# Access Compliance Report

## Public Rights-of-Way

Intersection ID: 29647	Main Street: BALLYSHANNON_LN	Cross Street: SOUTHERN_GARDEN_LN	Location: SW
ADA ID: 36D064FDC239	Ramp Type: BlendTrans1	Initial Pass/Fail: Fail	Overall Compliance: No
Severity Score: 18.75			
Codes/Mitigation Info/Possible Solution		Field Measurements/Component Compliance

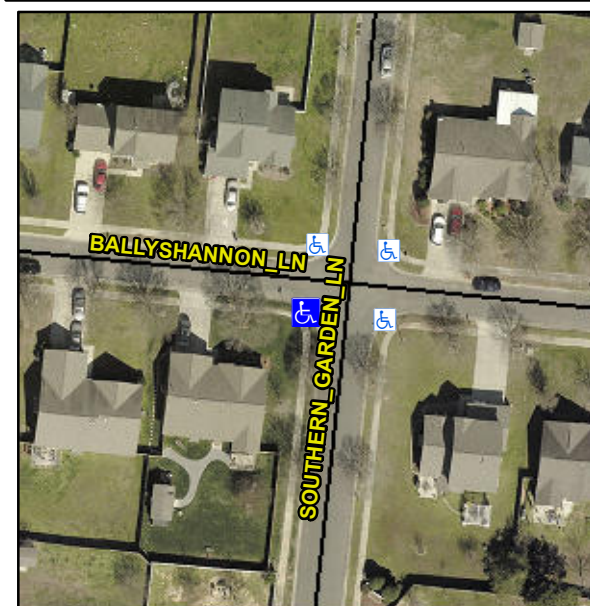
**R304.5.1, R304.5.3**

Compliance	Description	Data	Compliance	Description	Data
N/A	Ramp Length (in)	48.0	Yes	BlendTrans Slope (%)	4.7
No	Ramp Width (in)	34.5	No	BlendTrans XSlope (%)	4.1
N/A	Flare Type LT	N/A	N/A	Flare Type RT	N/A
N/A	Flare Slope LT (%)	N/A	N/A	Flare Slope RT (%)	N/A
N/A	Flare Traversable LT?	N/A	N/A	Flare Traversable RT?	N/A
N/A	Landing Length (in)	N/A	N/A	DWS Provided?	N/A
N/A	Landing Width (in)	N/A	N/A	DWS Contrast?	N/A
N/A	Landing Slope (%)	N/A	N/A	DWS Length (in)	N/A
N/A	Landing X Slope (%)	N/A	N/A	DWS Full Width?	N/A
N/A	Landing Curb? (Y/N)	N/A	N/A	DWS Offset (in)	N/A
N/A	Shared Landing?	N/A			
N/A	Gutter Ponding?	N/A	N/A	Gutter Slope (%)	N/A
N/A	Gutter Lip Ht (in)	N/A	N/A	Gutter X Slope (%)	N/A
N/A	Painted X Walk1?	No	N/A	Painted X Walk2?	No
	X Walk 1 Direction	To E		X Walk 2 Direction	To N
	X Walk 1 Width (in)	N/A		X Walk 2 Width (in)	N/A
	X Walk 1 Slope (%)	0.9		X Walk 2 Slope (%)	2.0
	X Walk 1 X Slope (%)	0.2		X Walk 2 X Slope (%)	1.9

**Remove & Replace Curb Ramp With Two New Directional Ramps or Equivalent.**
